**Re: CambridgeSide 2.0 Project – Canal Park Design Review**

**CambridgeSide 2.0**  
**Canal Park Design**  
**Review Supplement**

# Canal Park Design Review Summary of Response to Comments

## SITE HANDRAILS

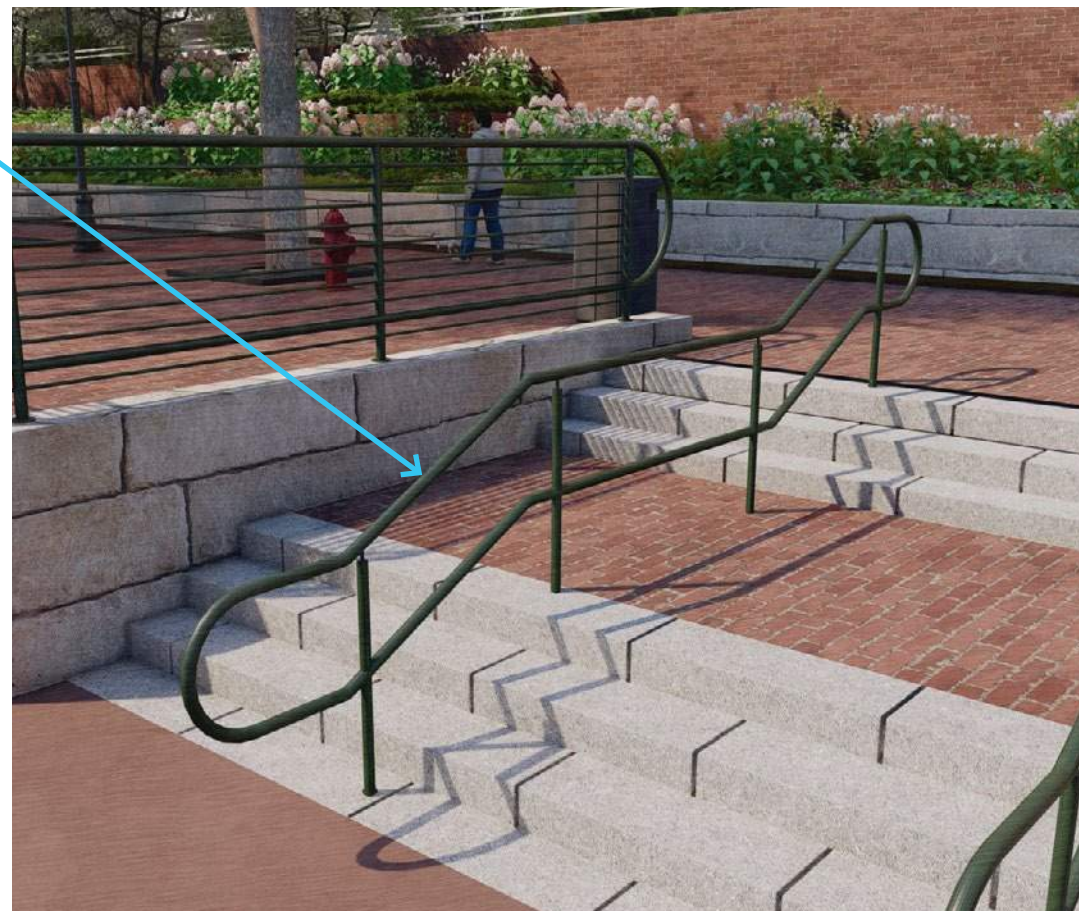
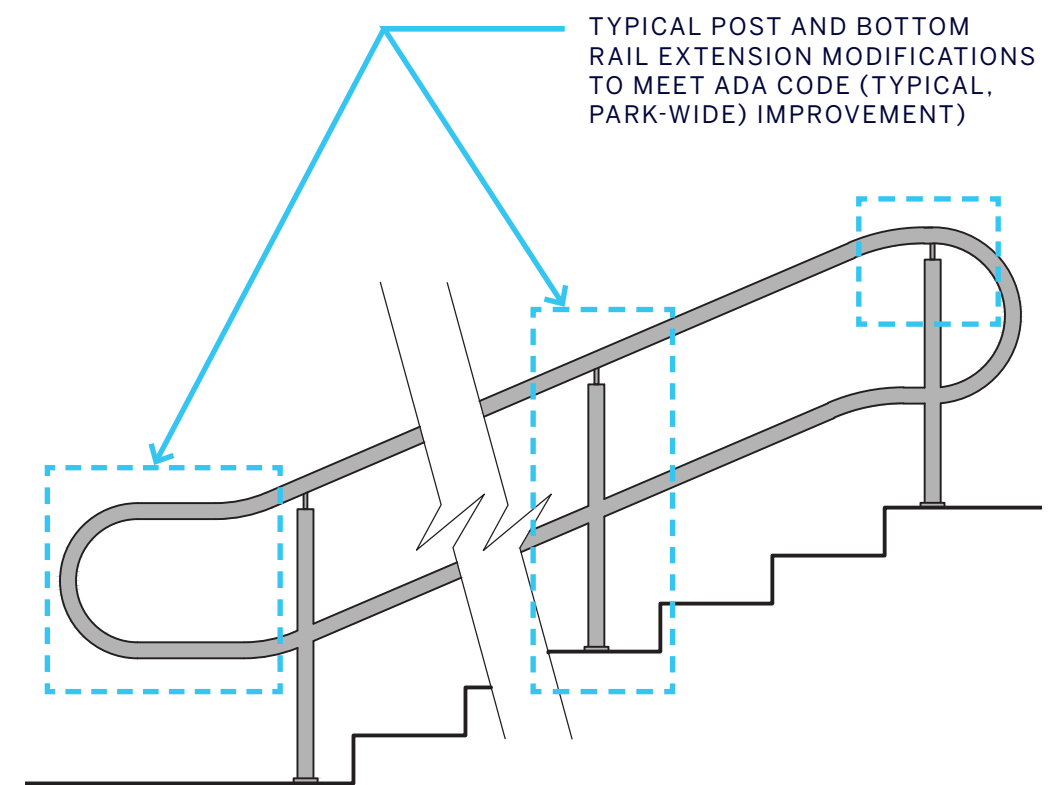
- b. **EXHIBIT 25B, Page 37:** In response to comments about the new guardrail, this exhibit has been updated to clarify design intent to reuse all stair handrails where possible. Modifications include the grab rail connection to the post and extending the top and bottom rails at stair landings to meet code. All newly constructed stair rails will match the detail shown on this exhibit for parkwide consistency.

FIELD CUT EXISTING  
RAIL, TYP

ALL SITE HANDRAILS TO  
BE REFURBISHED TO  
MEET ADA CODE  
(TYPICAL, PARK-WIDE  
IMPROVEMENT)

## BRIDGE WALKWAY: LIGHT FIXTURE AND CONNECTION

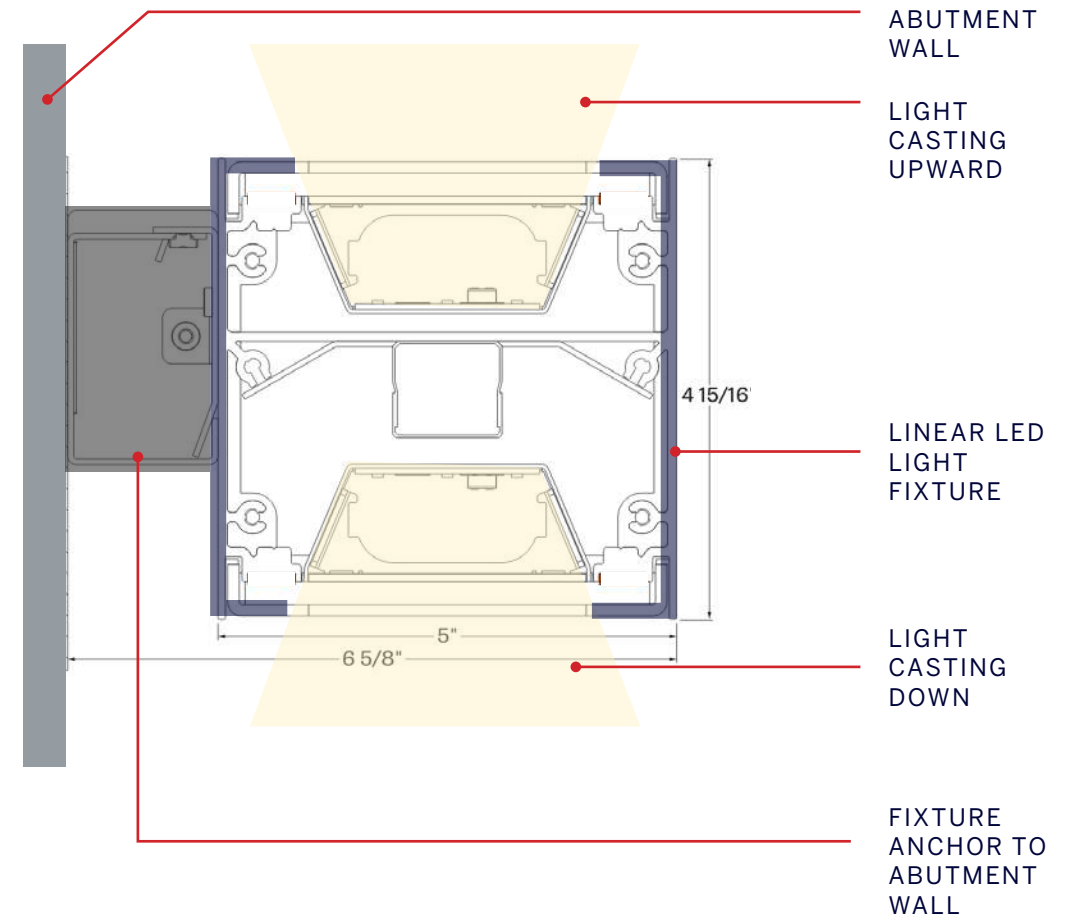
- a. **EXHIBIT 28A, page 41:** In response to a question about the lighting intent under the bridge, we have updated this exhibit to clarify that the proposed LED strip light fixture will cast light both up and down the abutment wall.

LINEAR LIGHT FIXTURE  
WILL BE MOUNTED TO  
ABUTMENT WALL

DUAL SOURCE LIGHT FIXTURE  
- MODEL NUMBER VSPLWDI  
- LED FIXTURE CAST LIGHT DOWN ABUTMENT WALL AND UPWARD TOWARD UNDERSIDE OF BRIDGE

# DESIGN REVIEW CANAL PARK BLUE BIKE STATION LOCATION AND DIAGRAM

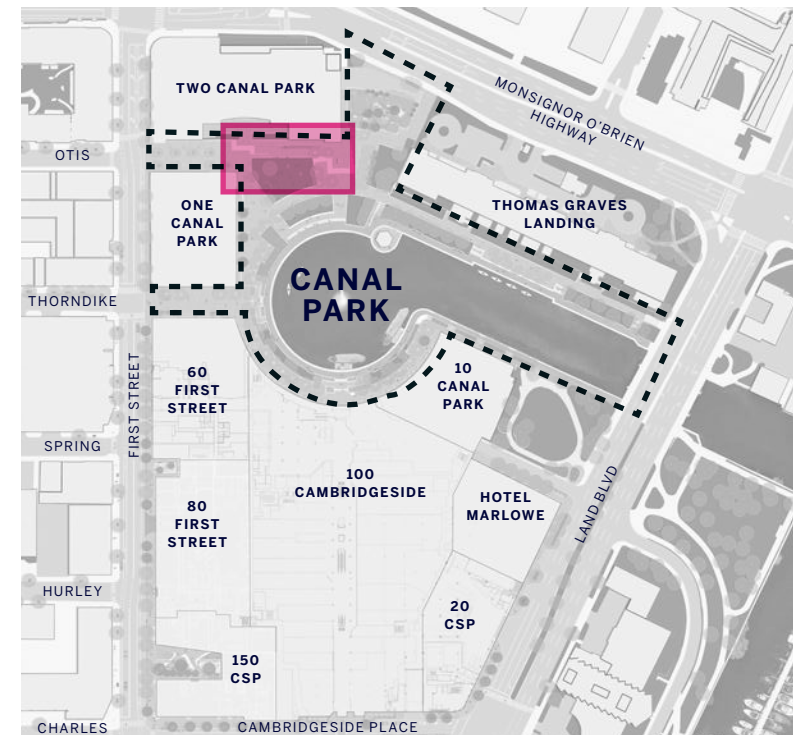
- b. **EXHIBIT 50A, Page 65:** In response to a request to better understand the locations studied for placement of the Blue Bike station, we have included the analysis diagram that served as the guide for selecting a preferred location. Study Area 2 was the preferred location for the Vendor and CDD staff based on the analysis; as such, Study Area 2 is the proposed location for the Blue Bike station.

27 BLUE BIKE DOCK STATION

GOOD VISIBLE CONNECTION AND PHYSICAL PROXIMITY TO FIRST STREET

VIEW CORRIDOR AT OTIS STREET

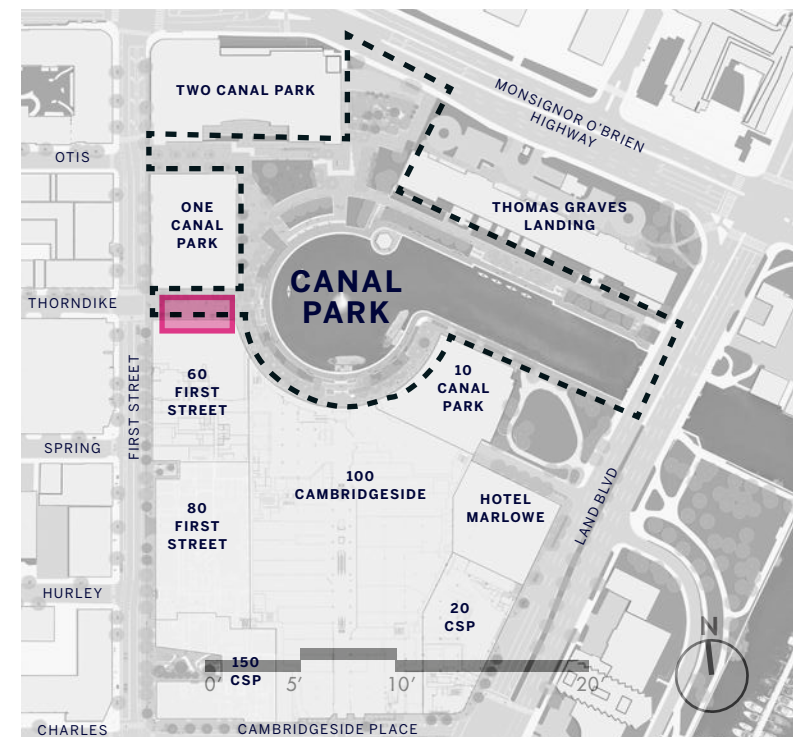
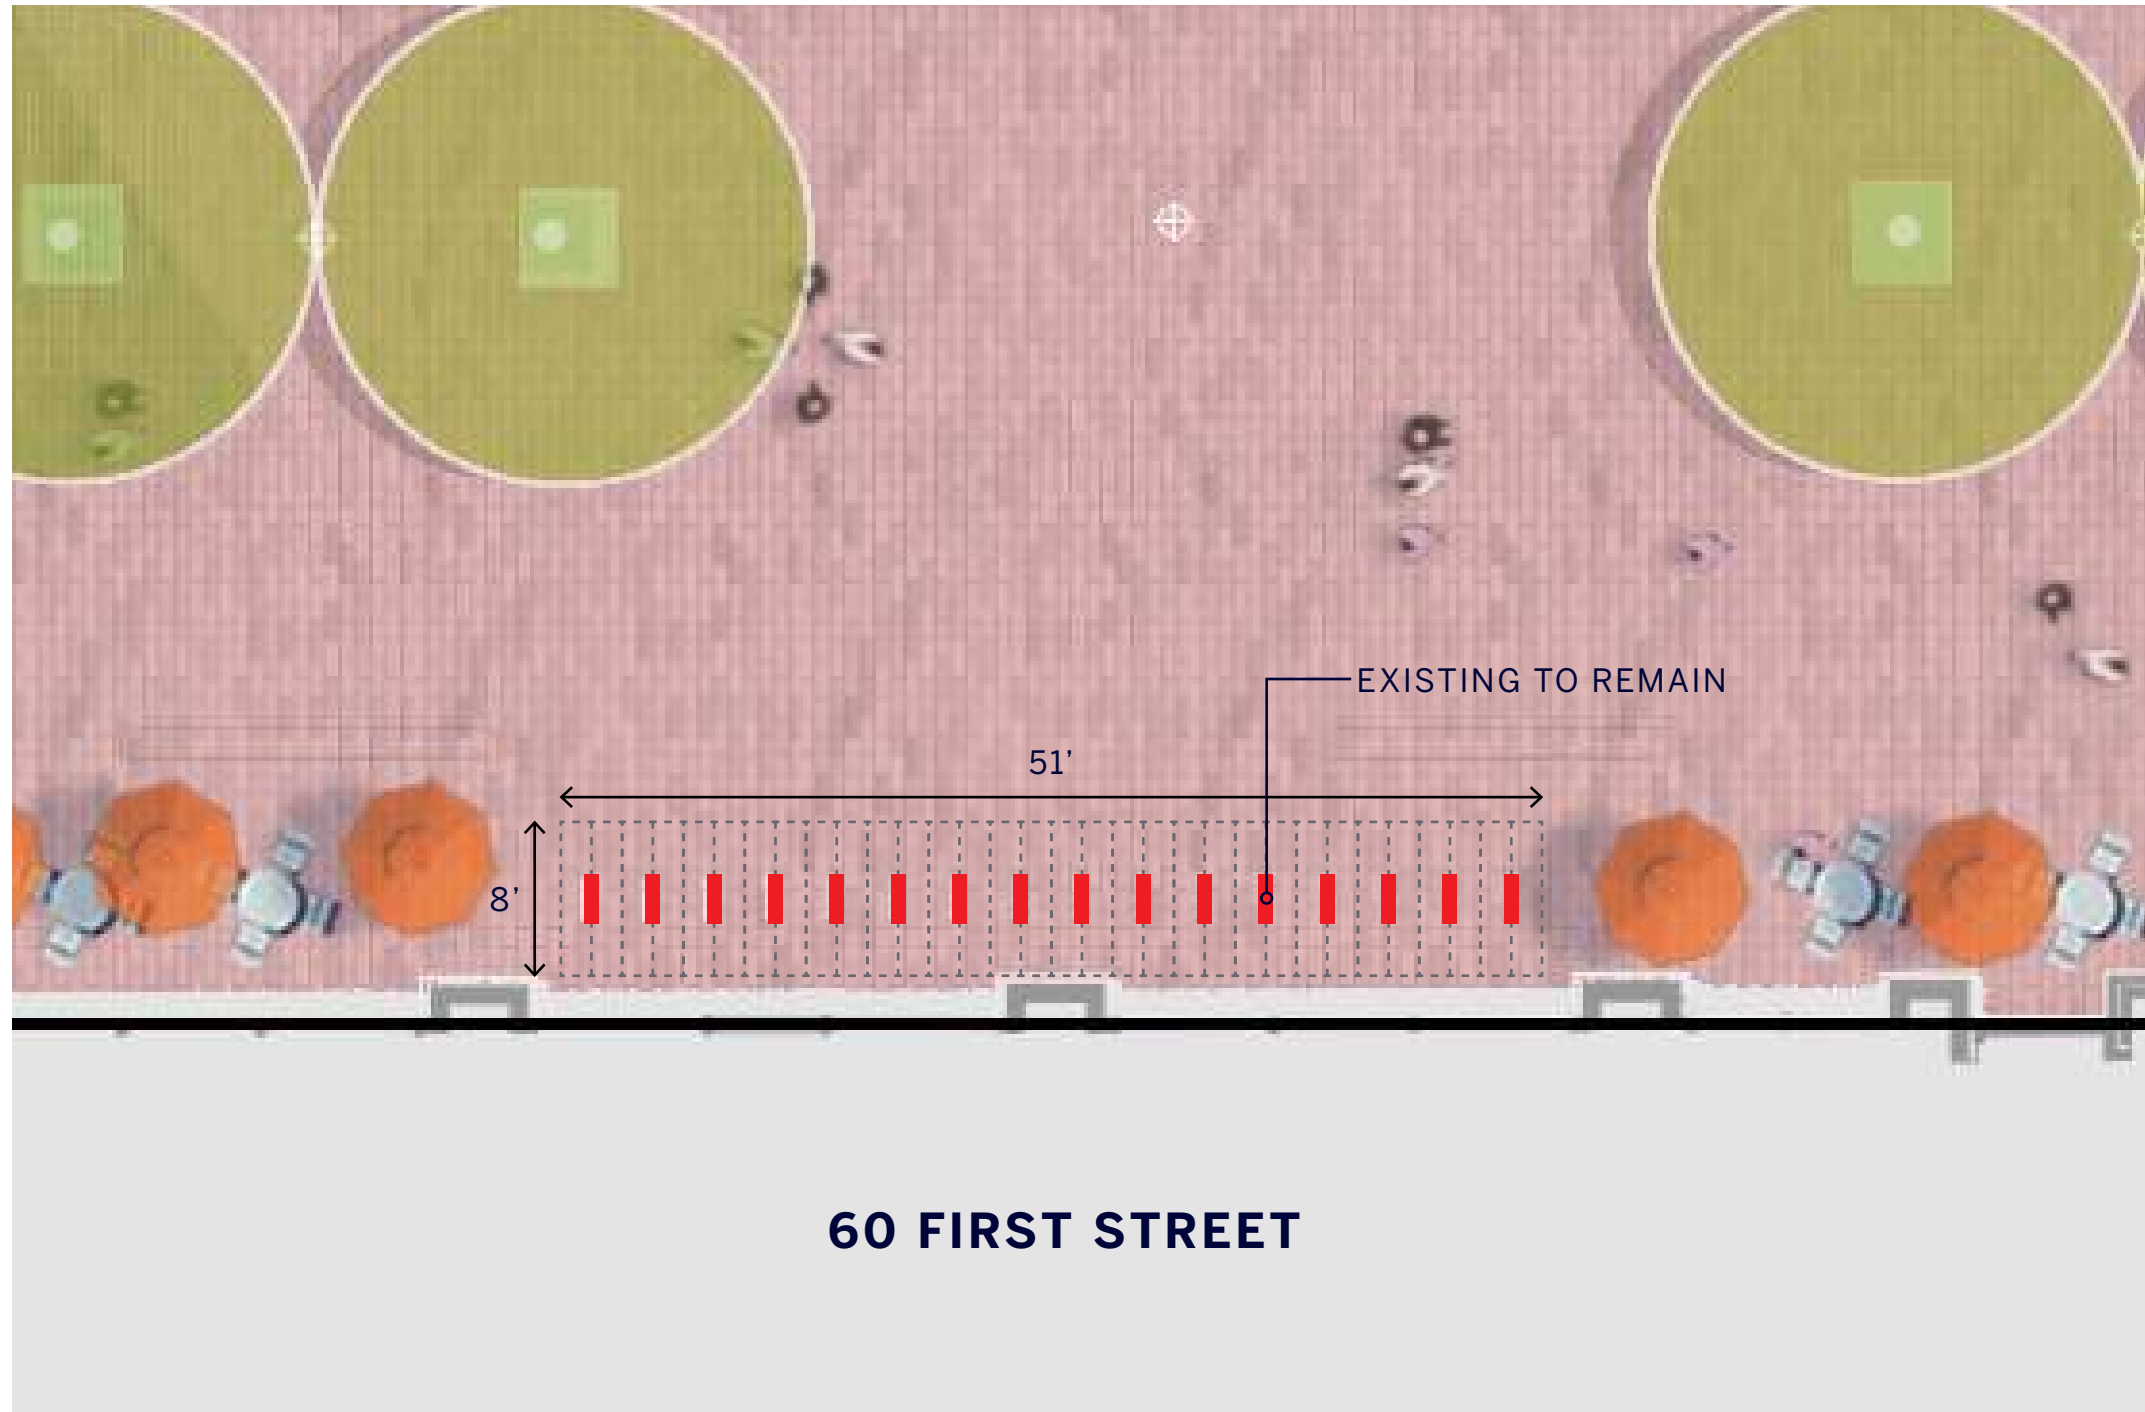
- c. **EXHIBIT 50B, Page 66:** In response to concerns about Blue Bike parking in the Otis Street view corridor, we have prepared an exhibit illustrating that the proposed Blue Bike station location (shown diagrammatically in blue) is outside of the view corridor defined by the alley of trees. The axial view of the Great Lawn and Nevergreen Tree sculpture are preserved.

PROPOSED BLUE BIKE  
LOCATION

PRESERVE SITE LINE  
TO SCULPTURE
